DEVELOPMENT
CONSULTANTS, INC.

SUBJECT: 25-040 Loaf Land Subdivision - Comment Response

“LOAF LAND SUBDIVISION” AT MOUNTAIN ROAD, COPLIN PLANTATION, MAINE

**STREAM PLAN &
PROFILE**

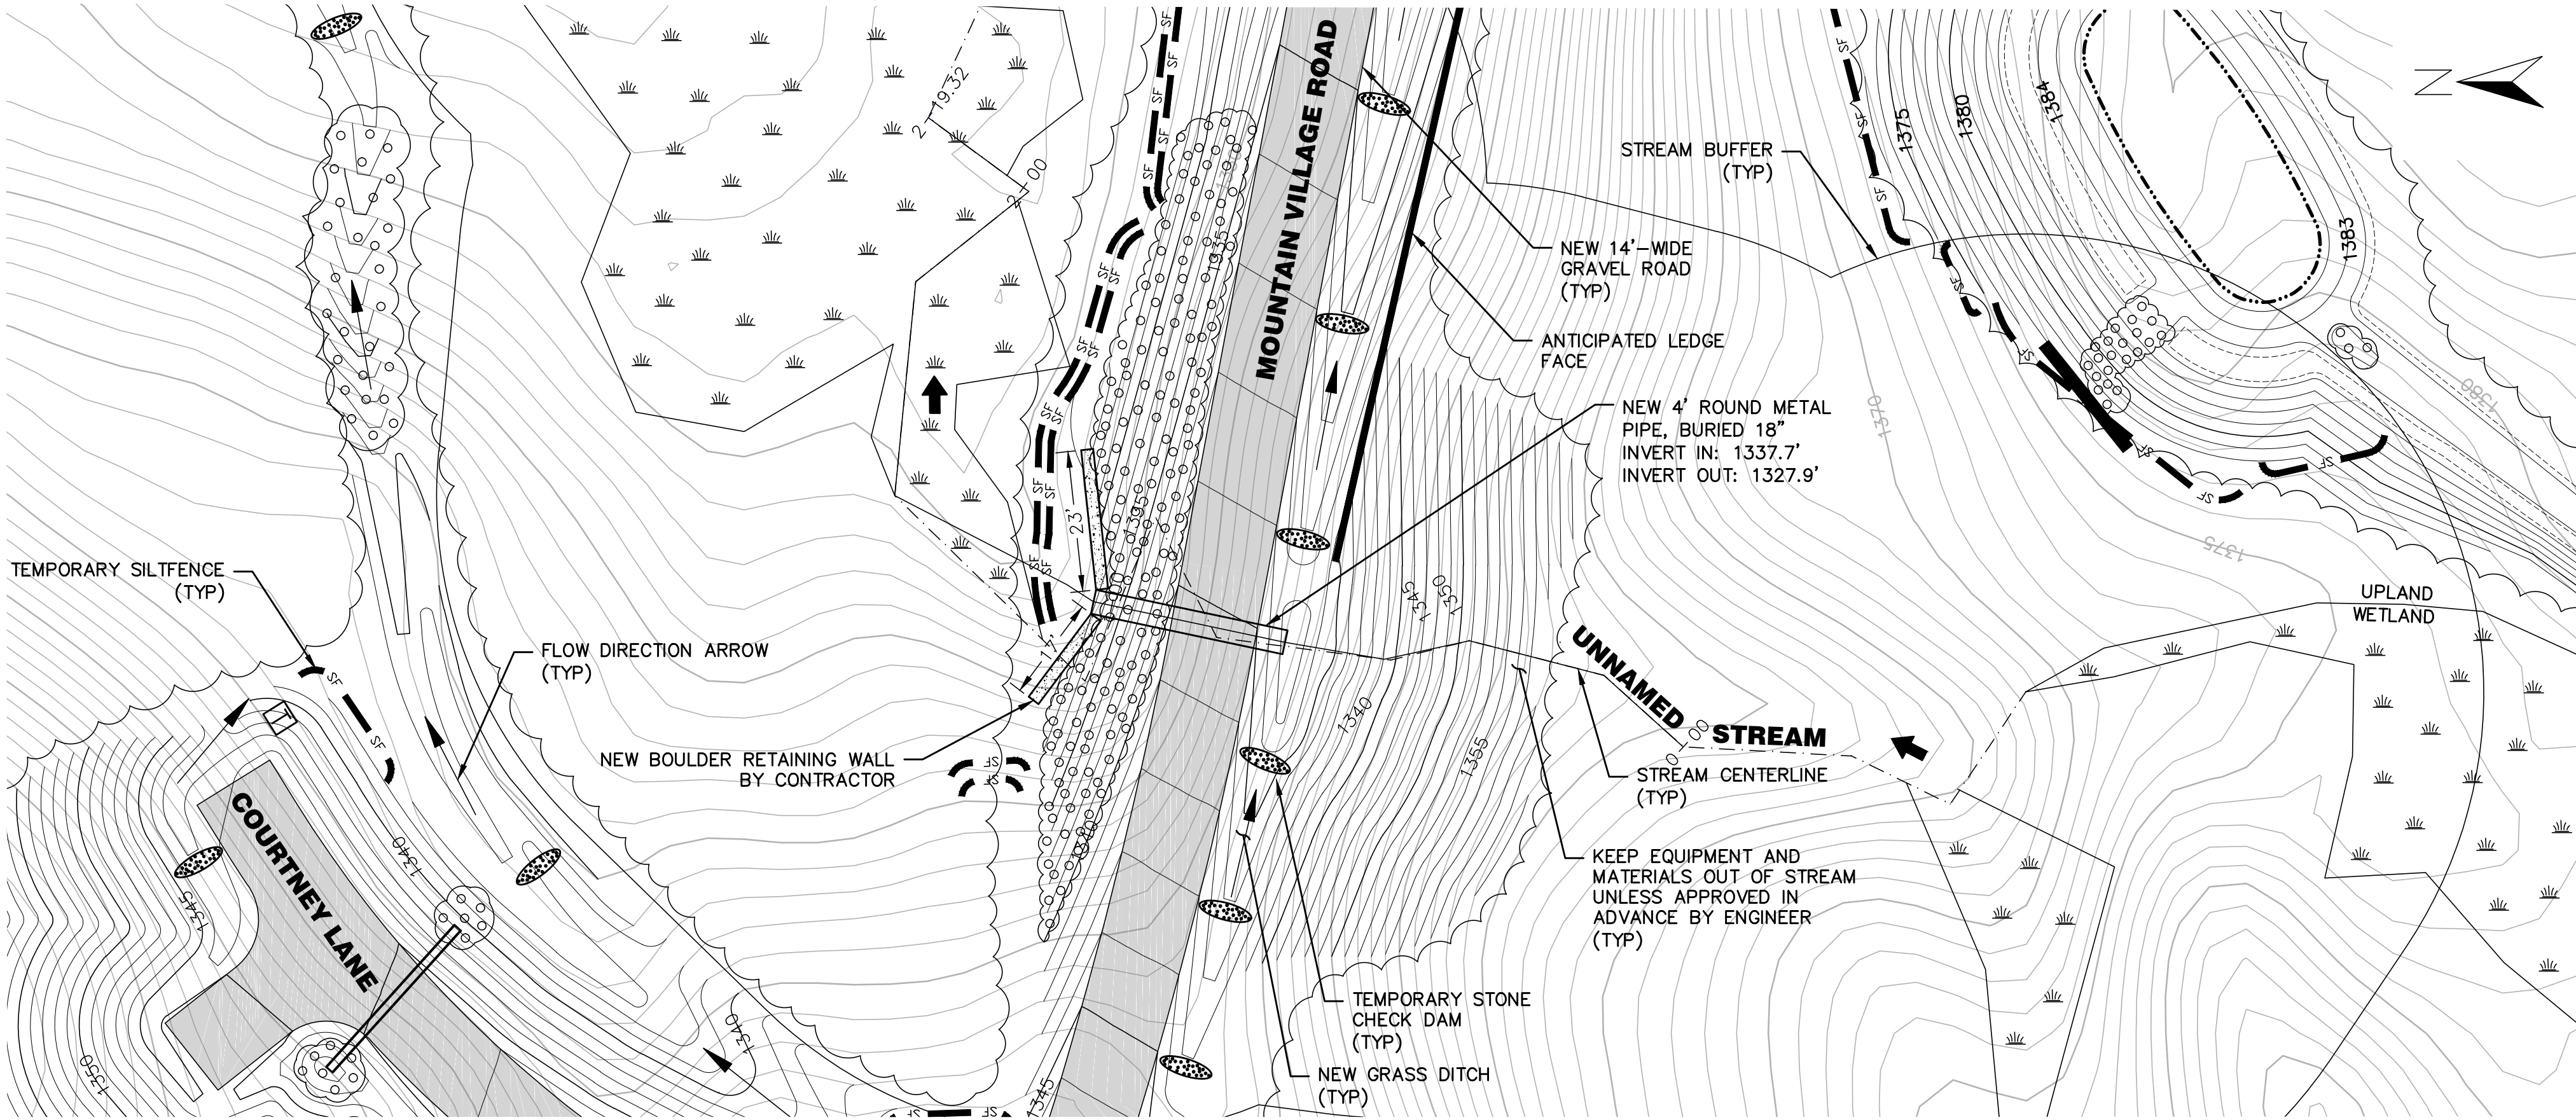
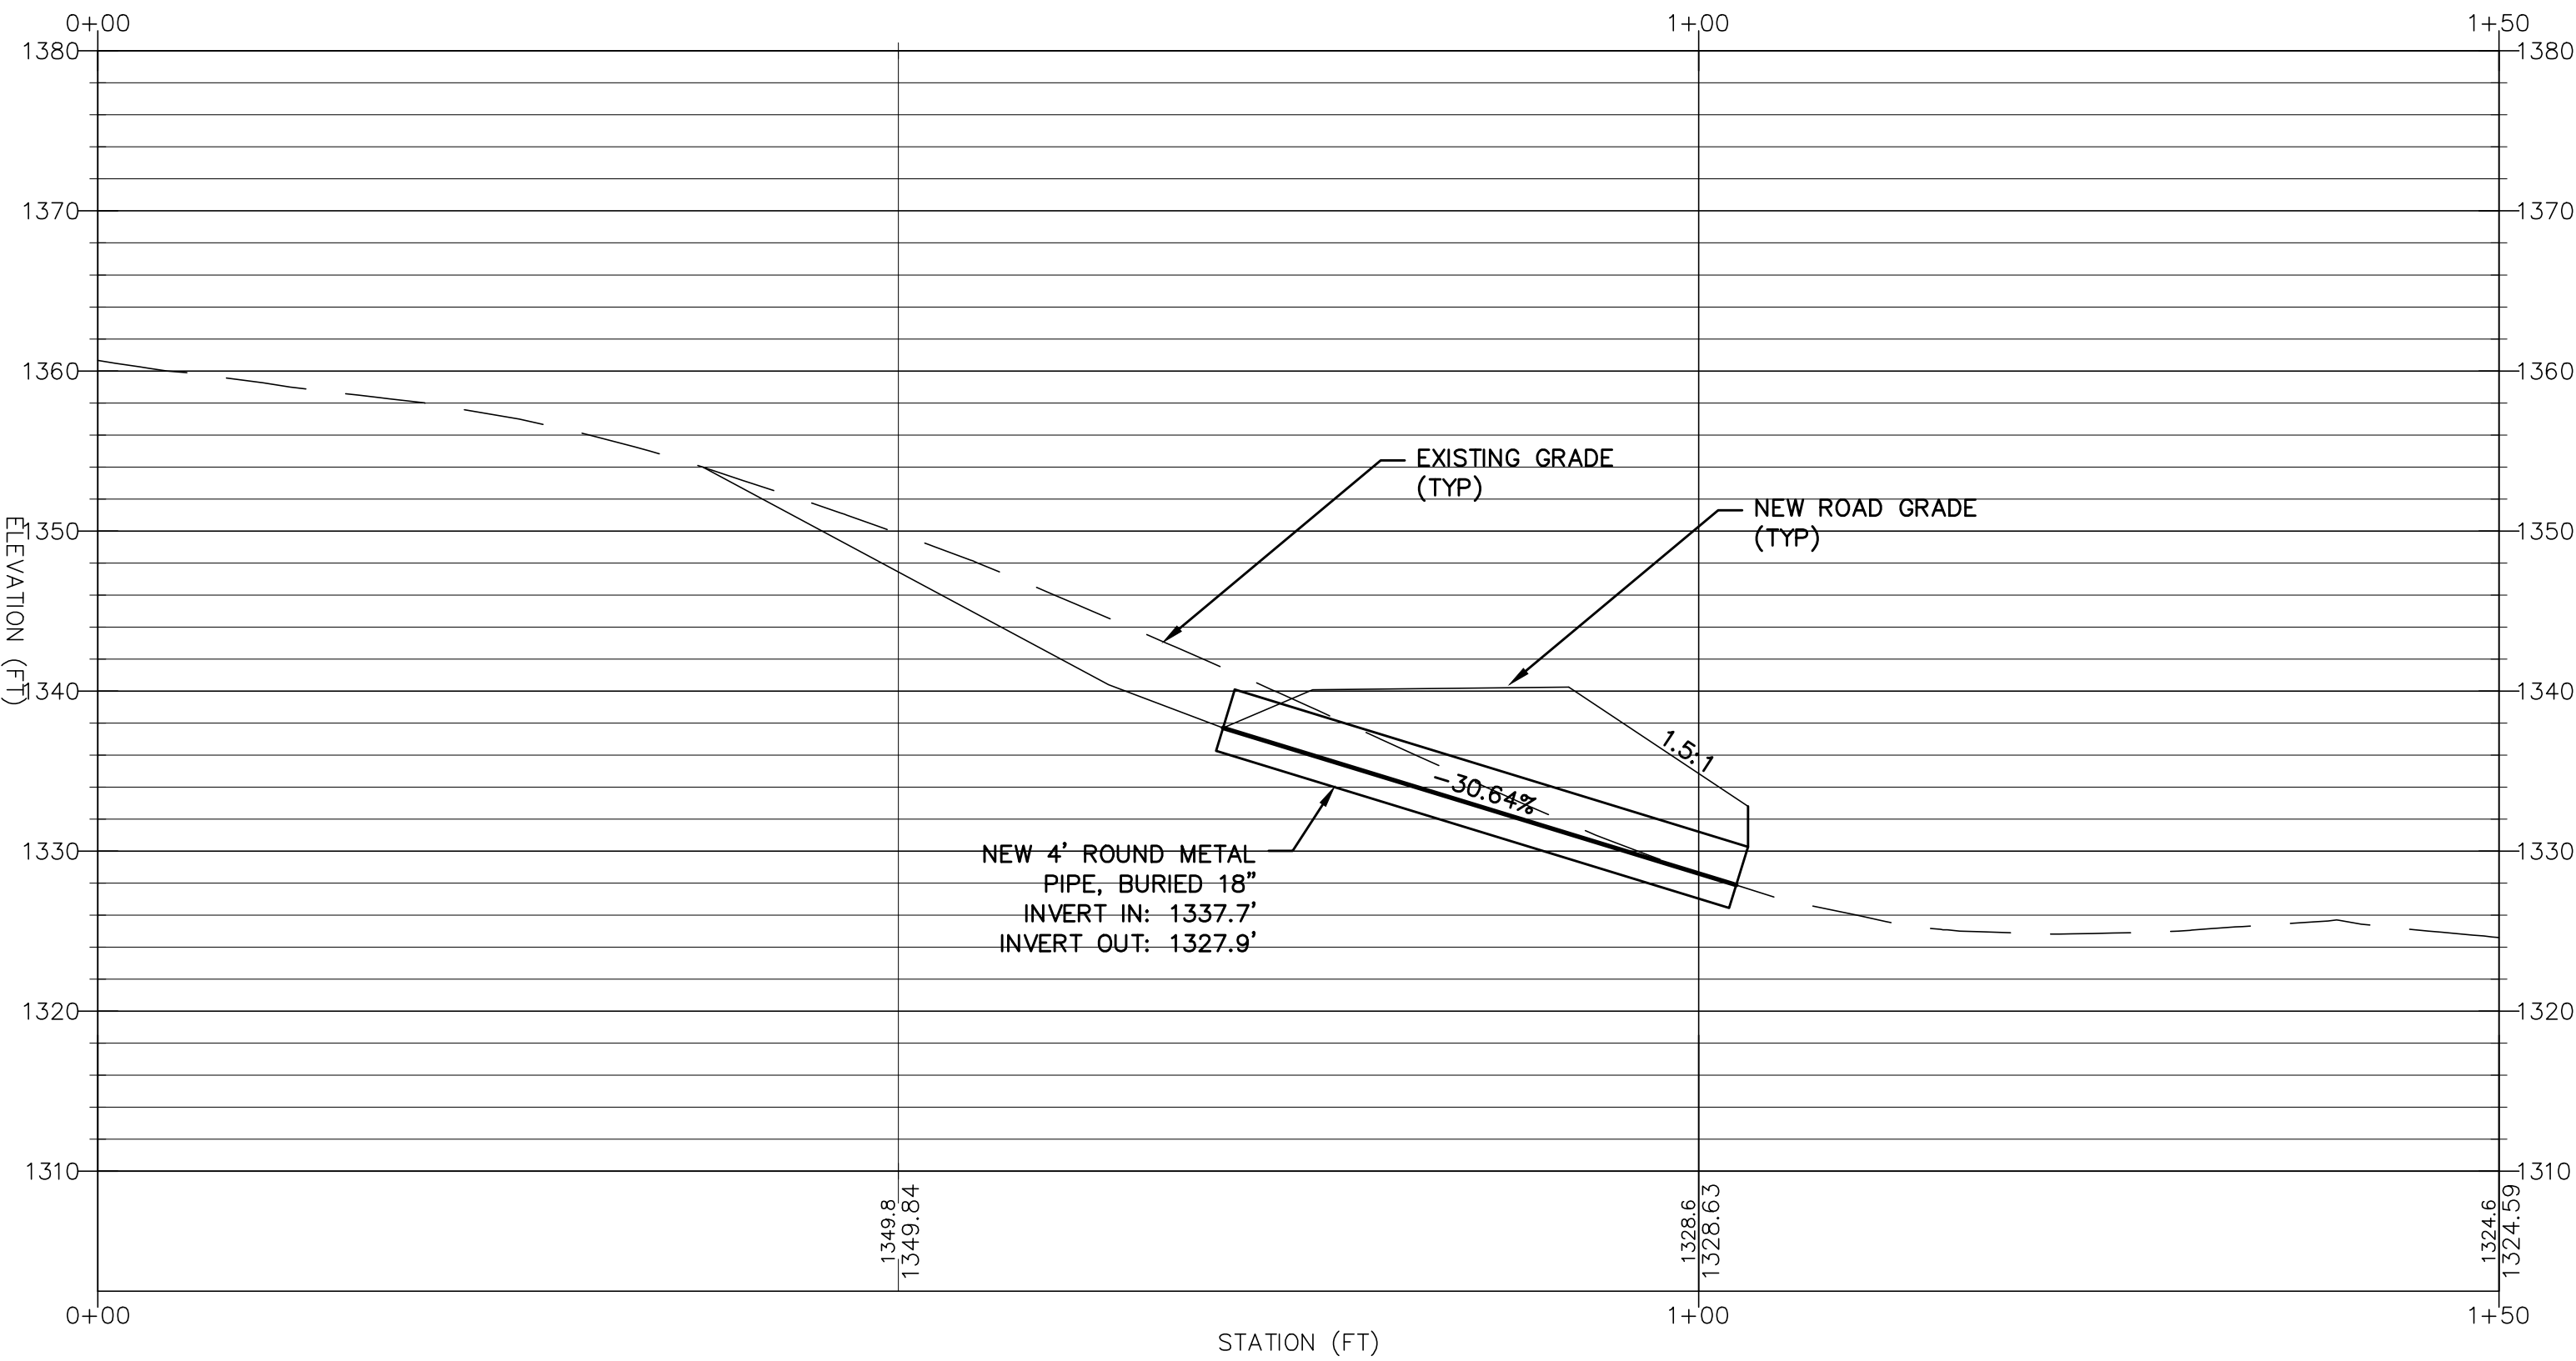
- *On Plan C5.3 (Stream Plan & Profile), clarify the design of the wingwall and how wetland impacts will be avoided during construction (see Sebago Technics review comment IV.11 on Sheet C5.3).*
 - *Sebago Response: The stream profile appears to indicate the need for a 7 foot-tall wing wall on the outlet side. The plans should better depict the design intent of this wingwall and how wetland impacts will be avoided during its construction. Silt fence is also shown through the wetland in this area with no stated wetland impact in this area. Additionally, the design plans include lengths of side slopes that are at 2H:1V or steeper. It should be shown on the grading plan which slope stabilizing measures are to be used and their extents where the side slope exceeds 3H:1V.*

The design plans have been updated accordingly. The wing wall design has been reduced to consist of a 4' wall, an acceptable height for a boulder wall installation by the contractor. The

siltfence and grading has been adjusted to provide more clearance adjacent to wetland. Lastly, the steeper sections have been indicated on C3.1 Grading Plan.

Image 1: Potential area that the project may be visual based on USGS Topographic Map

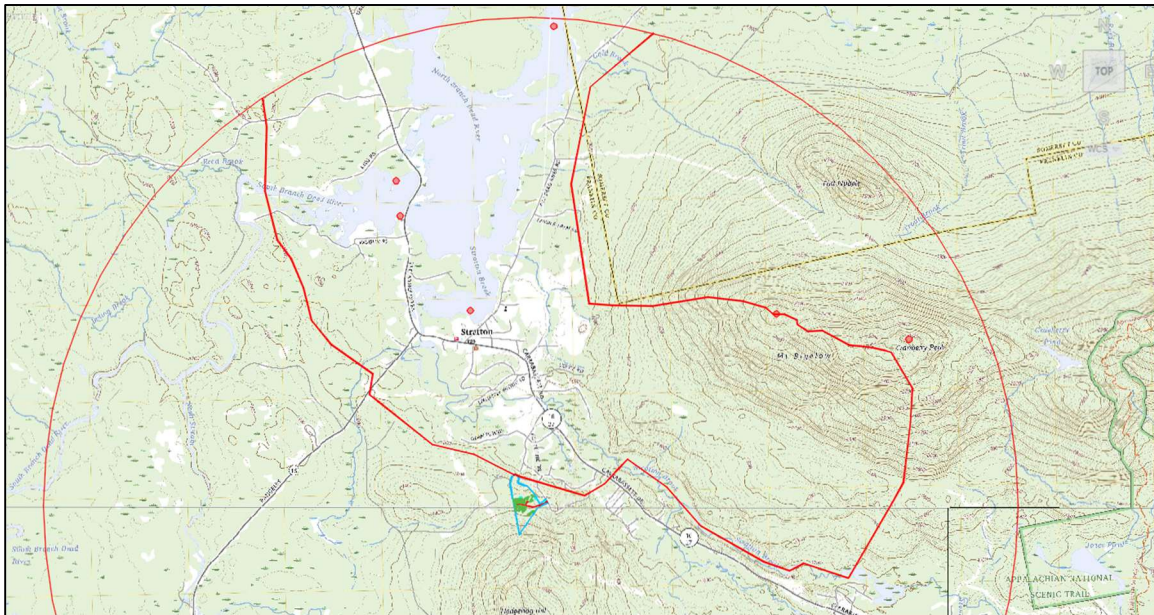
- *Harmonious Fit and Natural Character (Ex. 24)*
 - *Provide the methods for determining the viewshed depicted in Image 1 (p. 104).*

The narrative in Exhibit 24 has been updated to encompass this comment.

DRAWING NO. **D3.2**

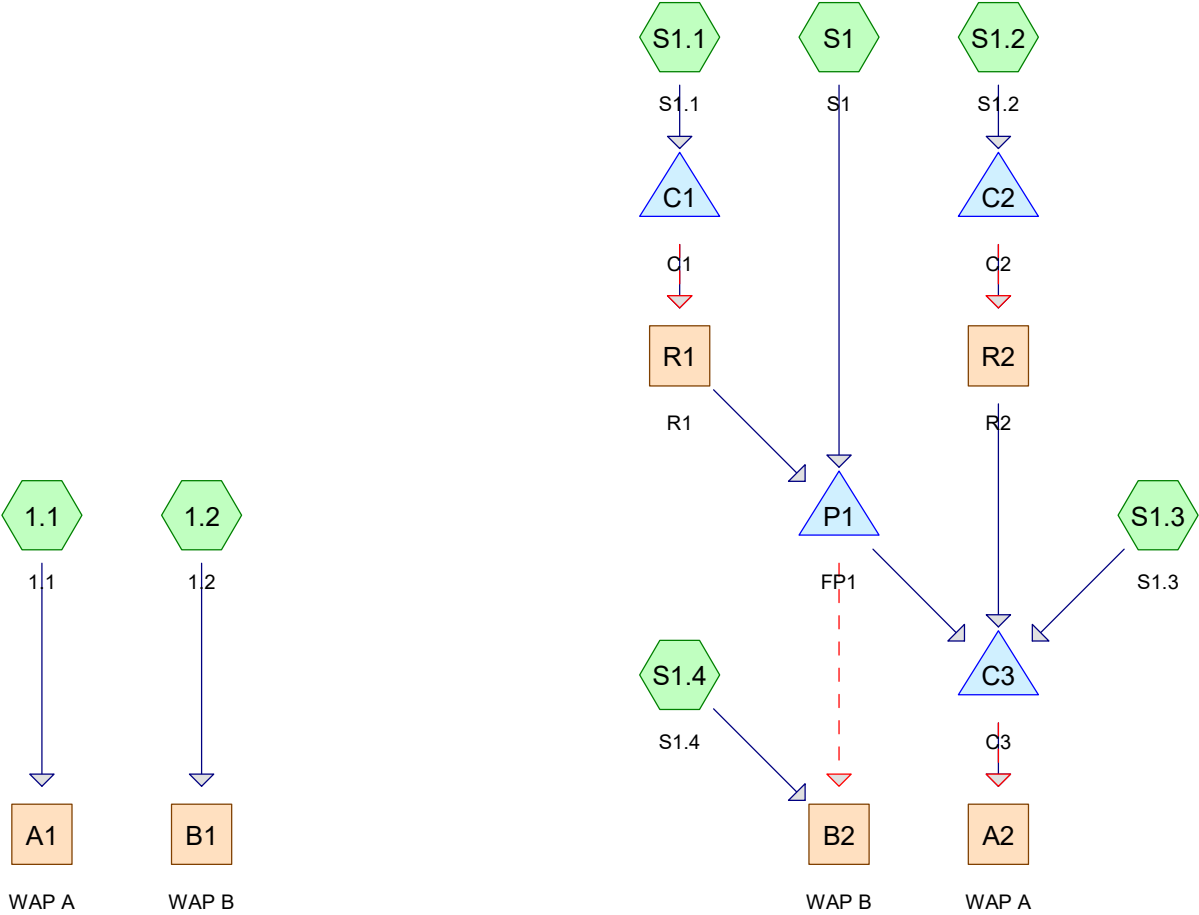
- *Address Sebago Technics review comment IV.1 regarding discharge from Filter Pond 1 and potential downgradient impact. Other exhibits may also need to be modified to address this comment.*

- *Sebago Response: Based on the installation of two 24 inch diameter culverts at this location and the discharge for the underdrained treated volume from FP-1, we are still unable to assess if this point discharge will have any impact on downgradient properties. We did not receive computations to review for pre or post development conditions looking at flooding conditions so it is difficult to assess if the rerouting from the existing condition will have any detrimental downgradient impacts onto abutting lands. The applicant states they are installing a level-lipped spreader to be located in the Mountain Road ROW but we did not see that improvement located on the plans. It is possible that runoff was channeling in the existing road trail and may have detrimental impacts at the intersection during large rain events, but based on the contours and plans attached for review it is difficult to 6 August 21, 2026 Loaf Land Subdivision – Coplin Plantation, ME LUPC Phosphorus Review assess the volume. The applicant shall provide appropriate culvert sizing to select the two-24 inch culverts to cross the new road and Mountain Road. The inclusion of the underdrained discharge from the treated runoff from the 4-inch line exiting the pond is likely a minimal influence on the final flow through the last 24-inch culvert. That evidence or statement of downstream impacts, eventual discharge from the parcel property lines, and next water course that the proposed drainage enters should be stated and presented by the applicant. We can decipher from the pond discharge in Hydrocad sheets included, that the larger flooding flows exit on the westerly side of the pond and discharge into an offsite wet area on the abutting property (Fish Jr and Jenny Burch land) which does by the ACME Land Surveying, LLC plan indicates by the topography provided. In principle we agree with the improvements but need calculations, evidence, and*

To provide further evidence indicating no adverse impacts, we have modeled pre- & post-condition at the Filter Pond 1 area and Mountain Road cross culvert. Attached in this response are drainage exhibits and HydroCAD modeling. This modeling represents the 25-year storm event and a slight decrease of flows at both analysis points.
